Response to request for review
Liaoning Beipiao Beitazi I Wind Farm Project (2830)

We would like to provide below initial response to the request for review raised by three Board members concerning TUV Rheinland's request for registration of the project activity 2830 "Liaoning Beipiao Beitazi I Wind Farm Project":

Metering diagram

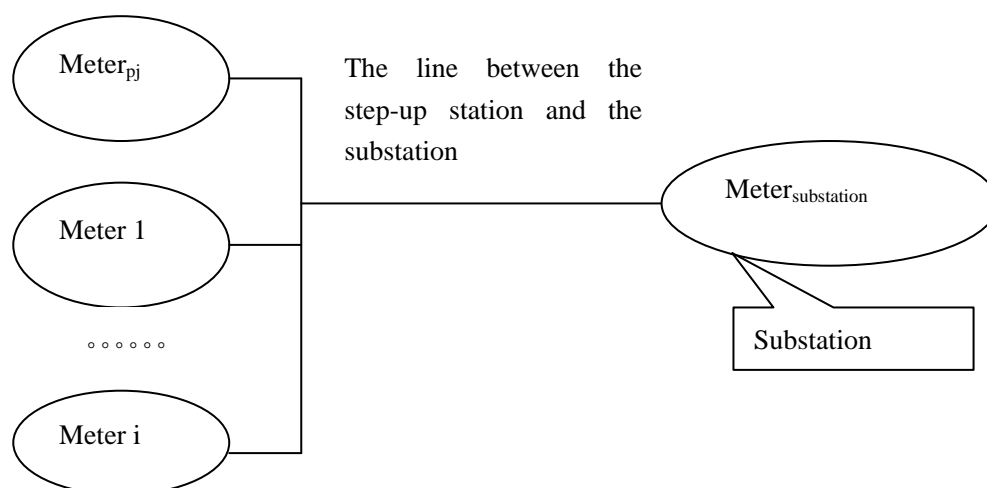
3. The DOE is requested to further clarify how the line losses between the step-up station and the substation will be monitored and to provide a separate table under section B.7.1 of the PDD.

As described in the PDD, the grid company required the project owner to share the line losses between the step-up station and the substation, and the project owner agreed to share it.

According to the Plan of the grid company, there may be wind farms connecting to the NECG through the same line in the future. Therefore, the process of monitoring the line losses between the step-up station and the substation is described as follows, which has been agreed by the grid company and the project owner.

Meter_{pj} is the meter installed at the 66kV step-up station of the proposed project;
Meter i (i=1,2, ..., i) is installed at the project i and measured the electricity supplied by the project i to the NECG;

Project i is the project used the same transmission line to connect to the NECG.

Meter_{substation} is installed at the substation to measure the electricity supplied to the grid through the same transmission line.

Then the line losses shared by the project

$$L_{pj} = (EG_{pj \text{ to grid}} + EG_1 + \dots + EG_i - EG_{\text{substation}}) * EG_{pj \text{ to grid}} / (EG_{pj \text{ to grid}} + EG_1 + \dots + EG_i)$$

So as far, there is no project connect to the NECG through the same transmission line.

Therefore, the $L_{pj} = EG_{pj \text{ to grid}} - EG_{\text{substation}}$

The grid company supplies the value of $EG_{\text{substation}}$ to the project owner to calculate the line losses between the step-up station and the substation.

If there are other projects connecting to the NECG through the same line in the future, the grid company will supply the value of EG_i and the value of $EG_{\text{substation}}$ to calculate the line losses according to the above formula.

The above description has been added in the B.7 of the PDD.
